SYSTEM/MODEL: RELAY

MODIFICATION: Modify RY-PA for normally closed contacts

CONVERTING THE RY-PA TO NORMALLY CLOSED

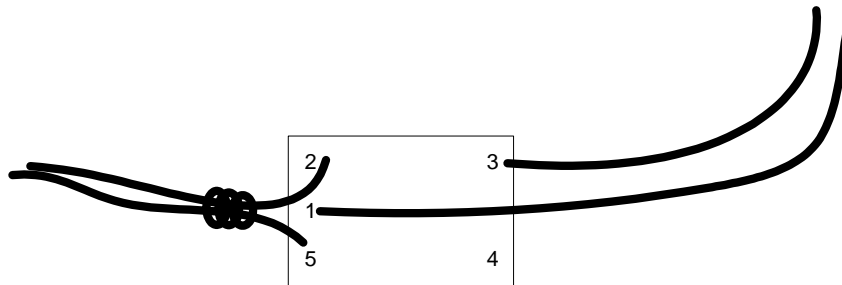
2. Locate yellow wire soldered to relay leg marked "3". Remove from that leg and resolder wire to leg marked "4".

Bottom view of relay within RY-PA as it comes from the factory. (Normally Open)

Bottom view of relay within RY-PA after field modification. (Normally Closed)
